MEETING:	REGULAR MEETING OF THE PLAN COMMISSION
DATE & TIME:	Monday, February 10, 2025 at 6:30 PM
LOCATION:	Germantown Village Hall Board Room N112 W17001 Mequon Road

FOLLOWED BY A 10-MINUTE RECESS
 - B. Capstone Development Company, Agent for CQ WI 2021, LLC Property Owner - N128 W20833 Holy Hill Road. Site Development and Building Plan Review for a 291,140 sqft Industrial/Warehousing Building in the Capstone 41 Business Park - Phase 3 (ACTION)

CAPSTONE 41 - PHASE III
PROJECT NUMBER: 079.22.121

© COPYRIGHT 2019
SANITARY SEWER & WATER MAIN PLAN (PRIVATE)

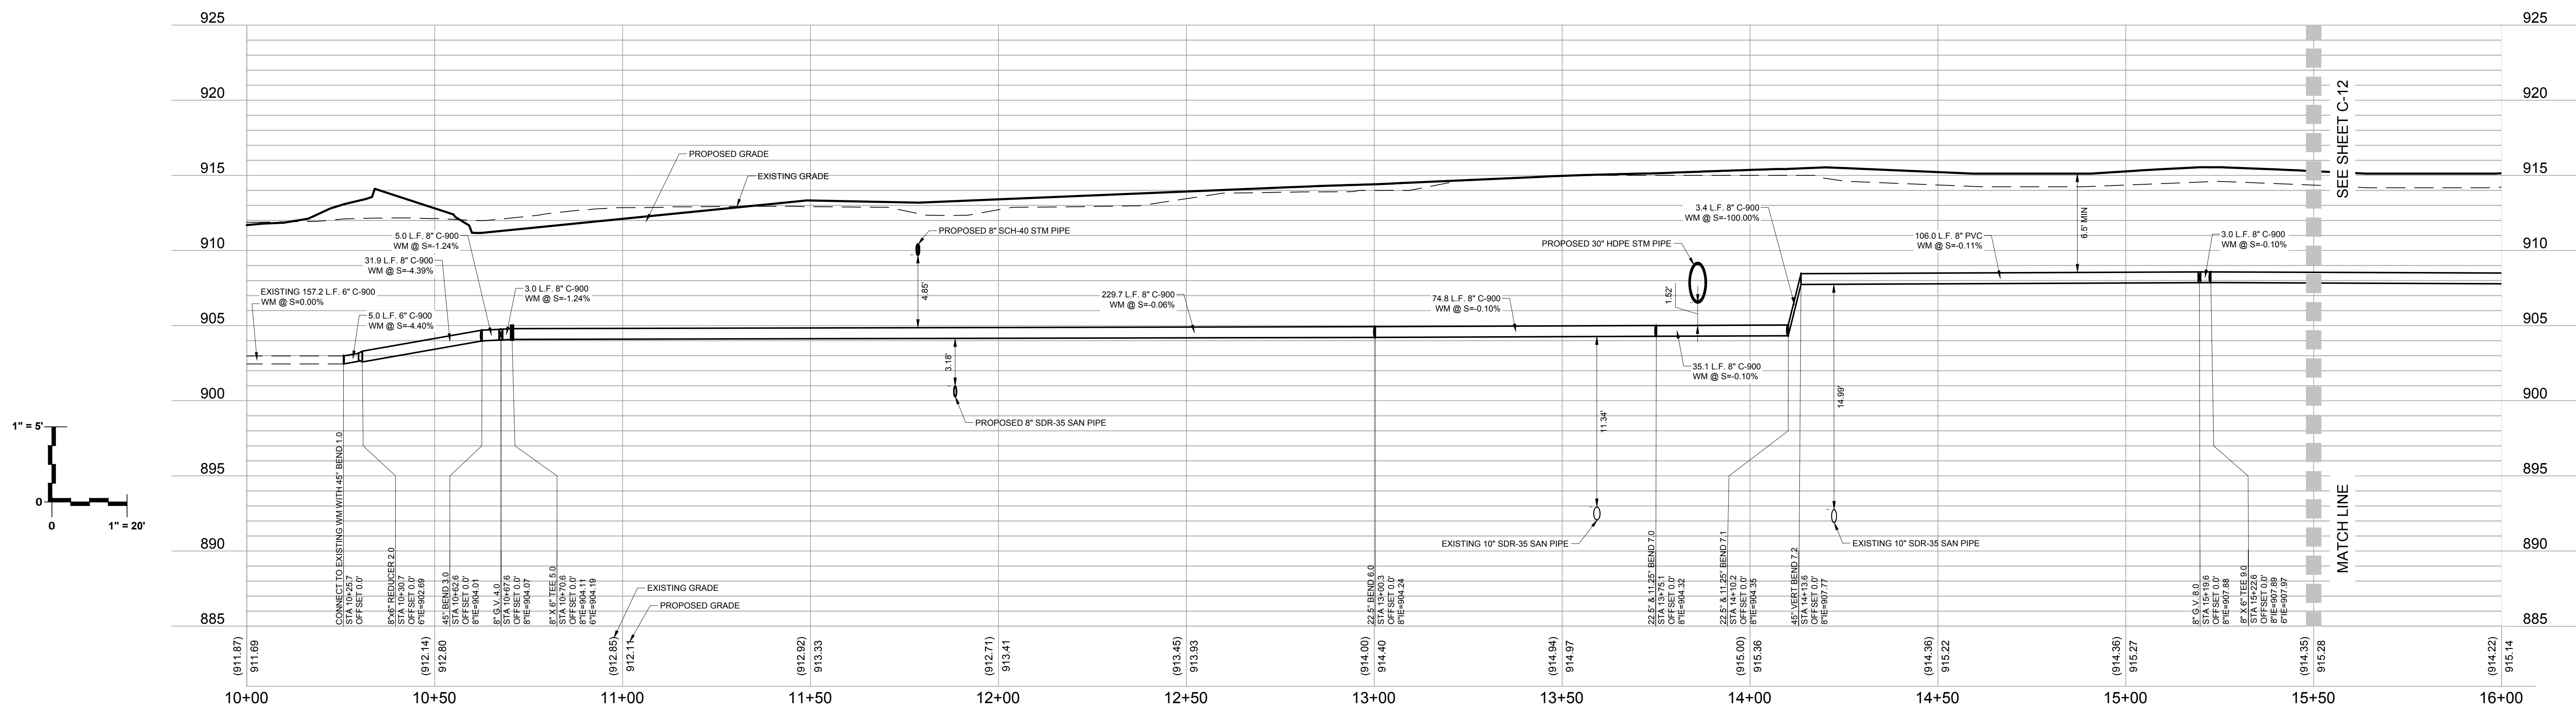
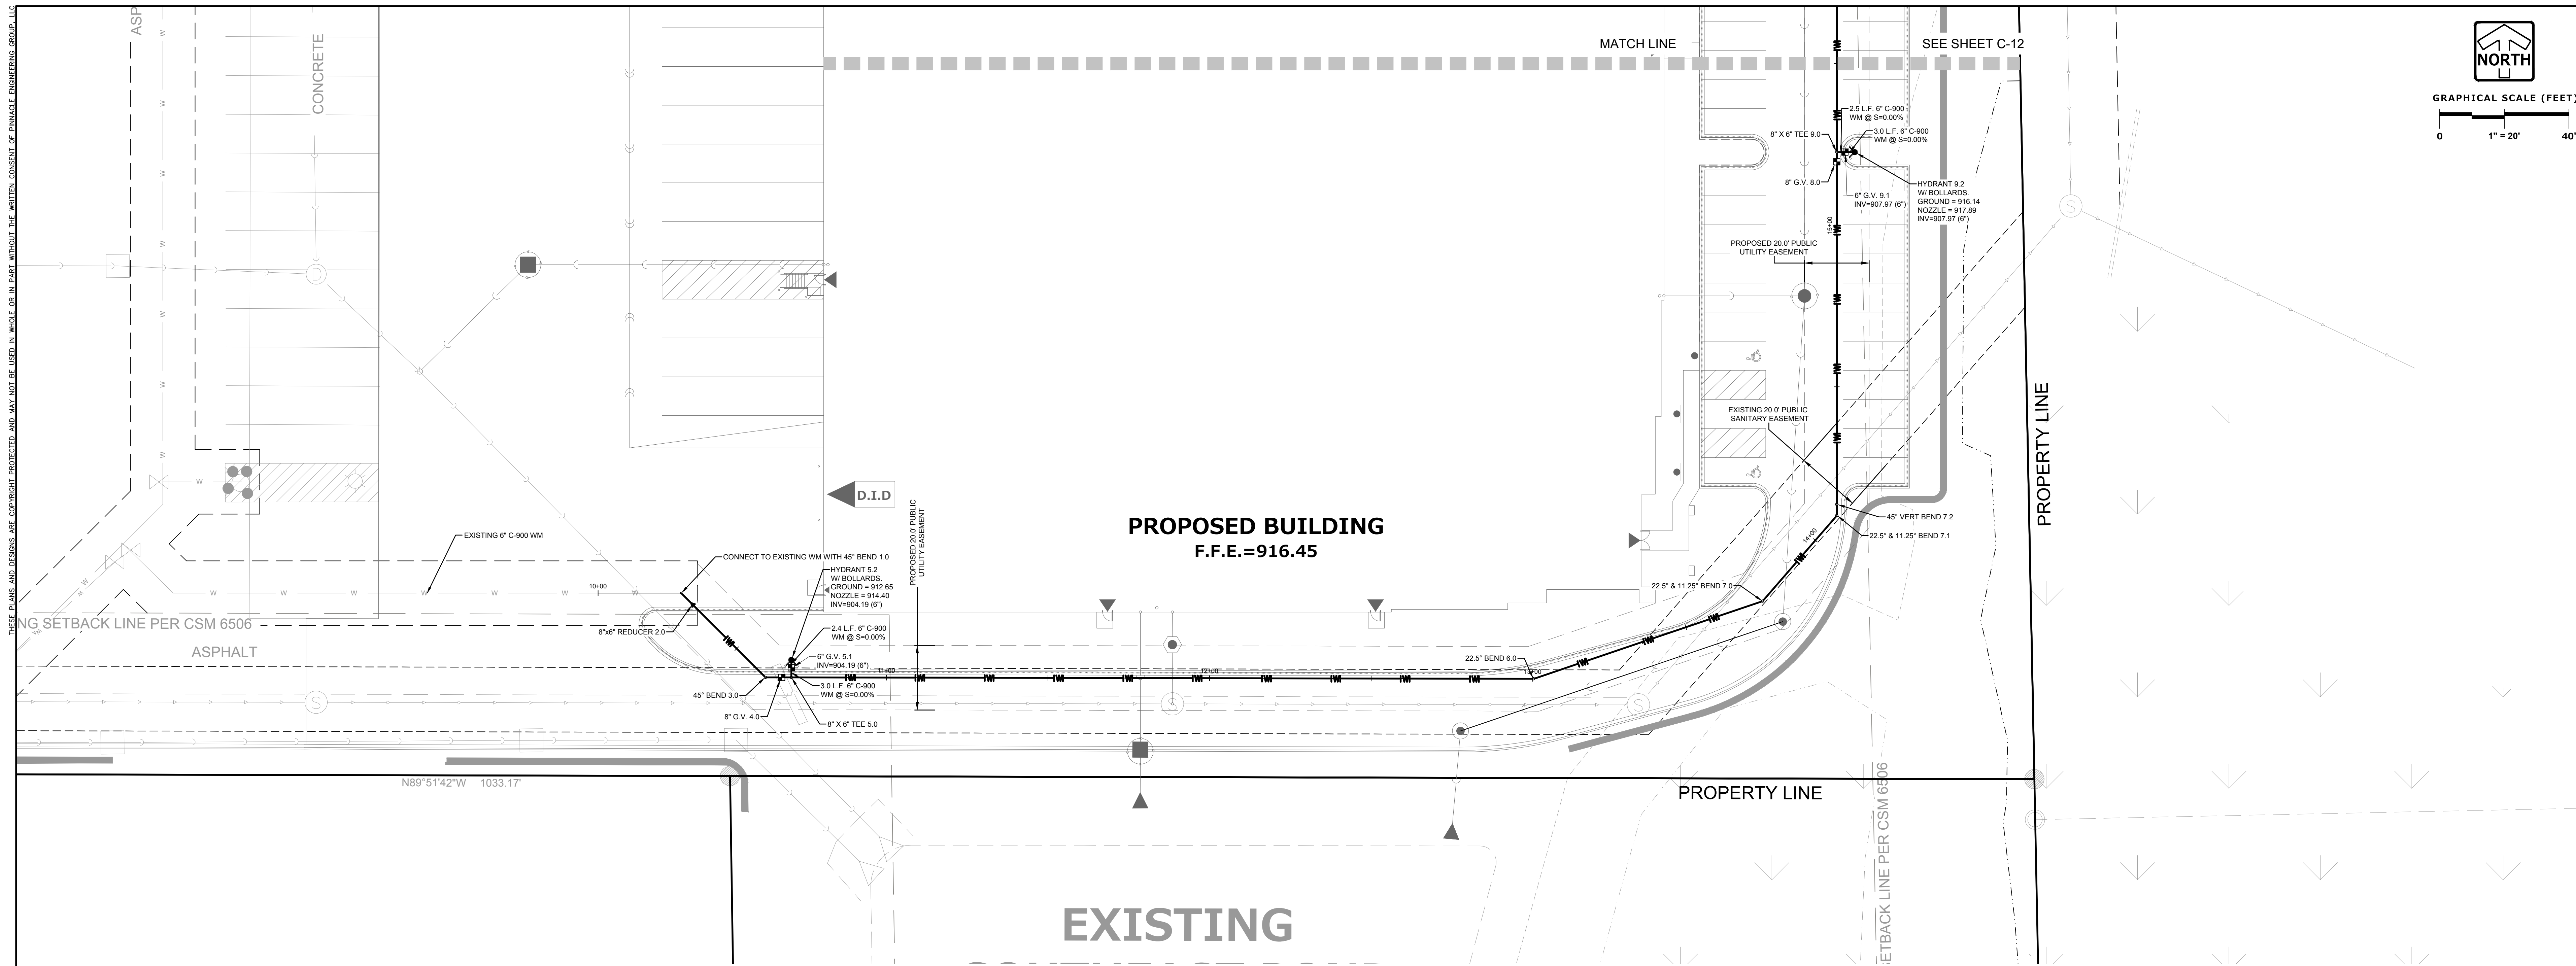
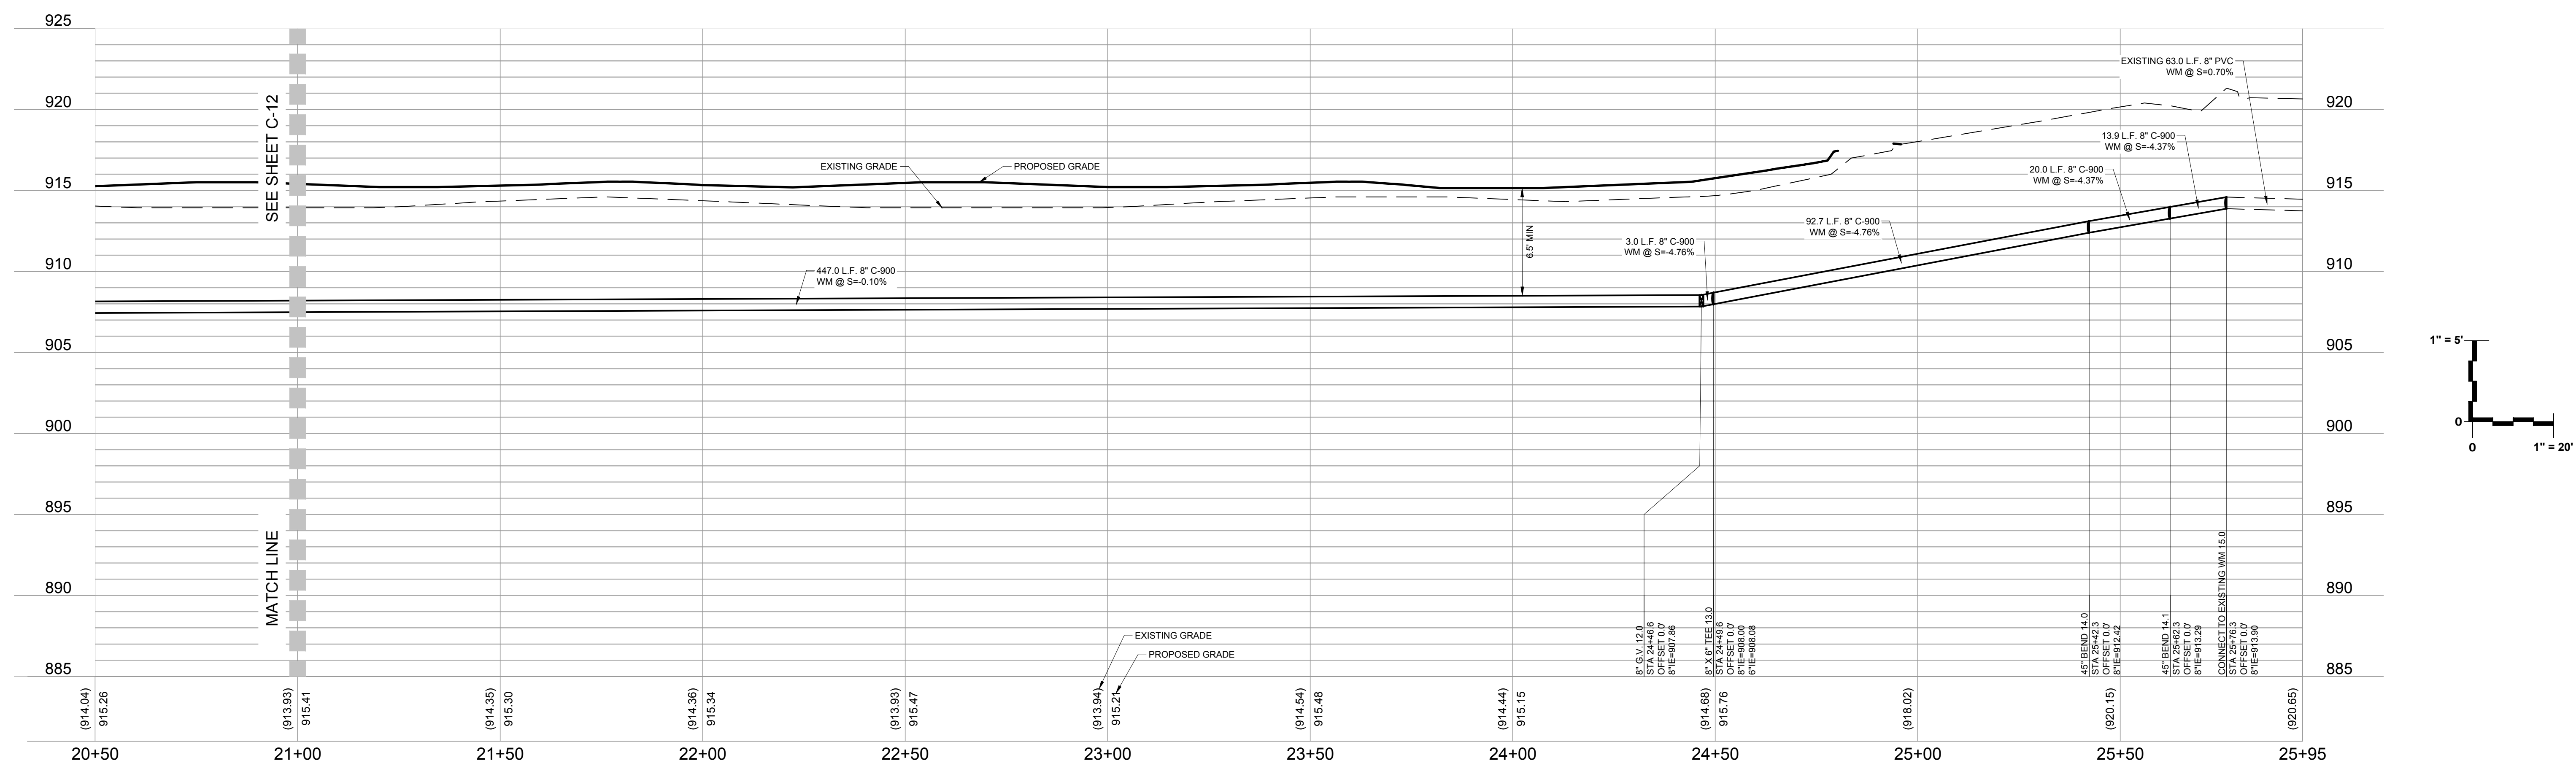
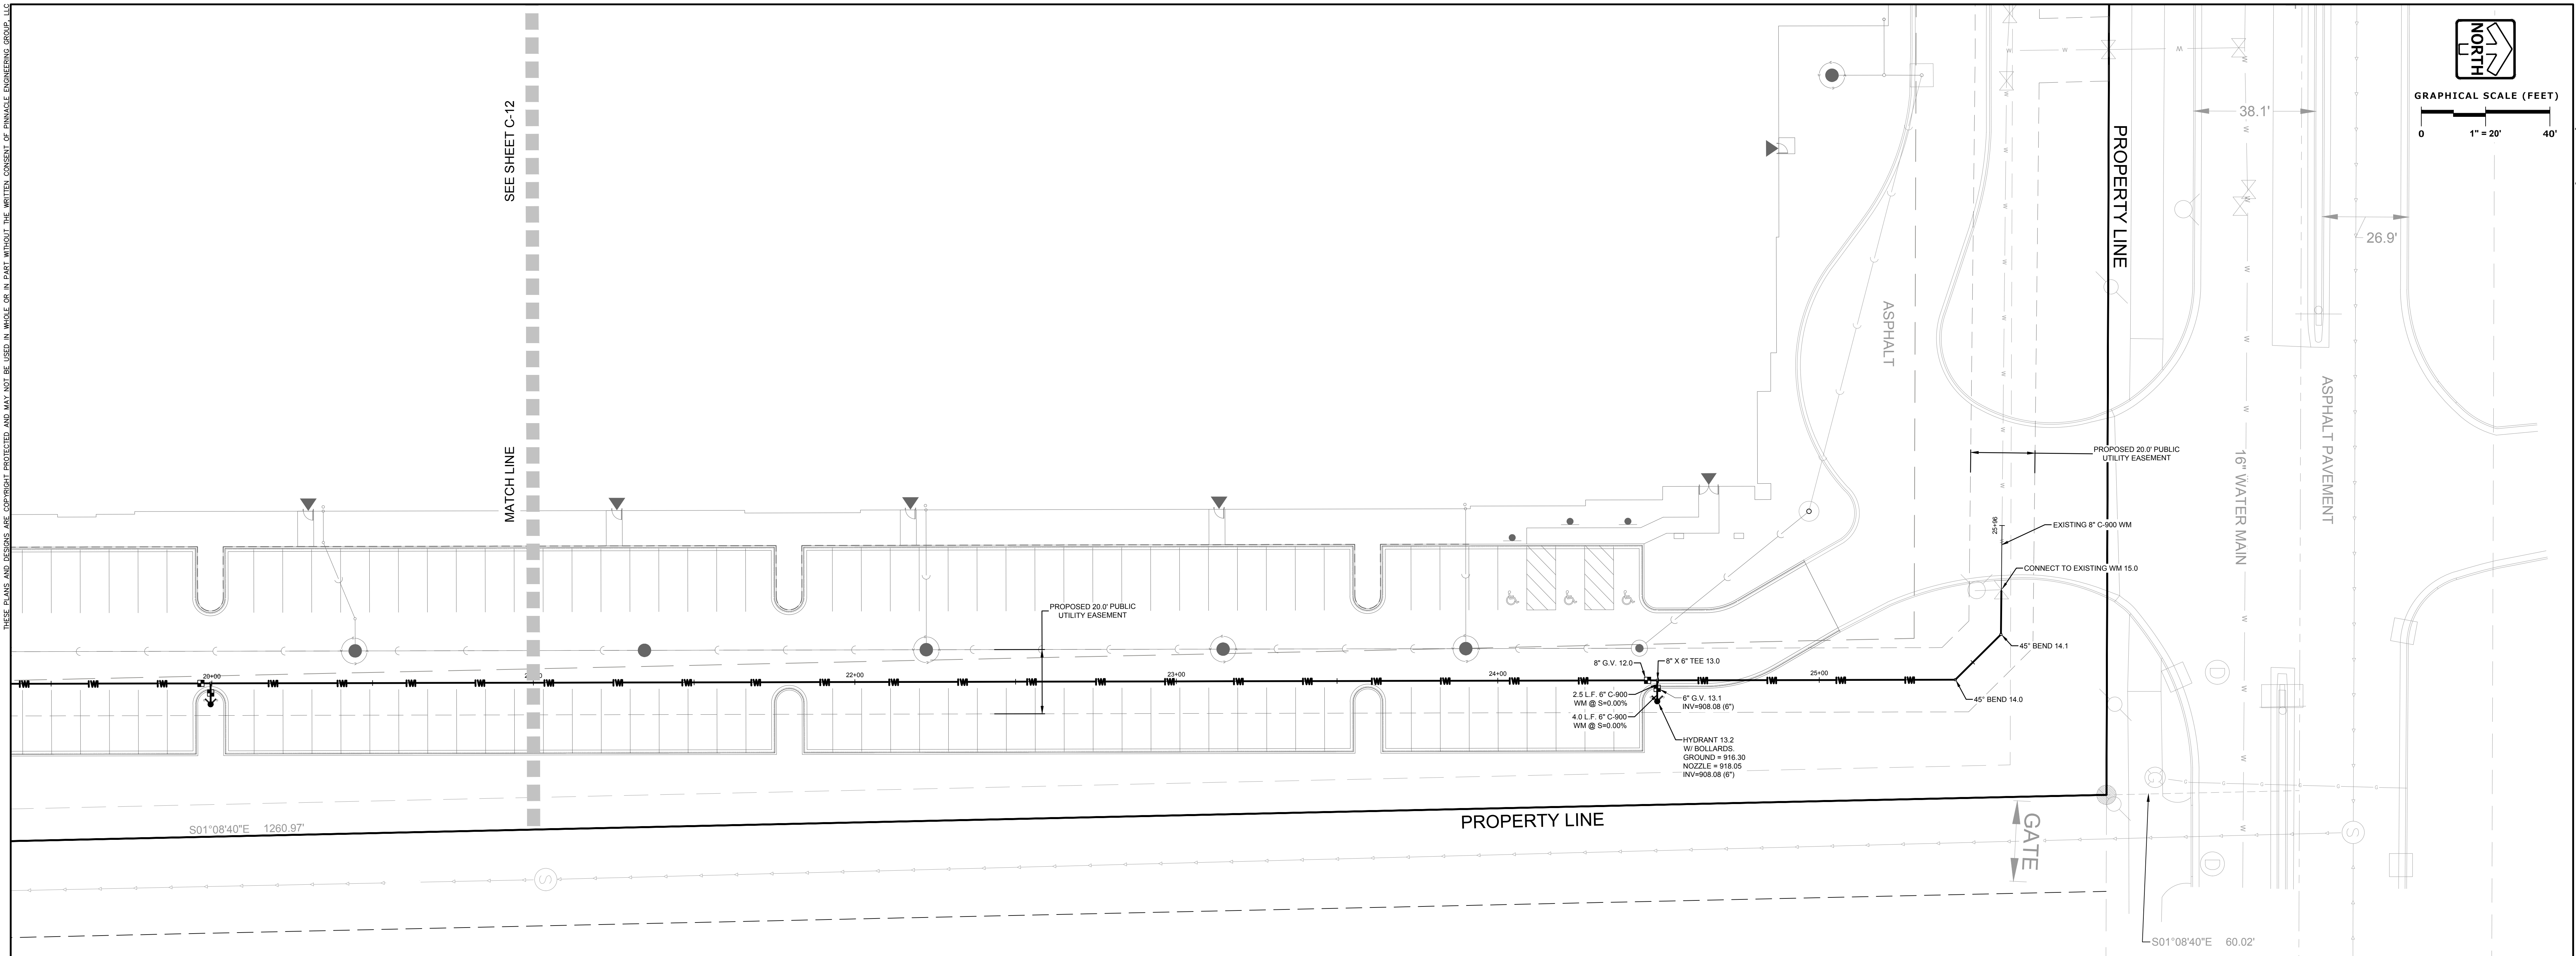
1. Crossings on Sheet C-10, Index of crossings is provided, however the corresponding call-outs for respective locations is missing. Update crossings with call-out corresponding locations.

2. Lateral on Sheets C-10 & C-11, connection lateral to mainline. Sample manhole is required. Per Village of Germantown Development Handbook, (3.1.6.2.5), Lateral connections to manholes shall not be made unless pre-approved by the Wastewater Superintendent. Connections to manholes in new construction shall not be above the outlet sewer crown and have a smooth paved channel constructed to convey lateral waste to main outlet channel.
3. Lateral on Sheet C-11, Contractor to provide submittals for water tight connection consistent with requirements in Development Handbook.
4. Sanitary Submittals to be transmitted to Wastewater Utility Superintendent and Village Engineer for review prior to the pre-construction meeting.

- Sheet C-9 - Tracer Wire – Note #17 Tracer wire references state statute but does not refer to Village of Germantown Development Handbook. Revise to reference compliance with Section 2.1.11 of the Villages standards where Open Cut tracer wire will be Copperhead #1230-HS-30mil.

- Sheet C-9 - Tracer Wire – Note #15, the tracer wire section is an incorrect call out, remove #10 solid and use #12 solid wire.
- Sheet C-11, At the connection point from Ph III to Ph II. Remove and salvage existing hydrant. Install new hydrant. Contact Water Utility for salvaging hydrant.
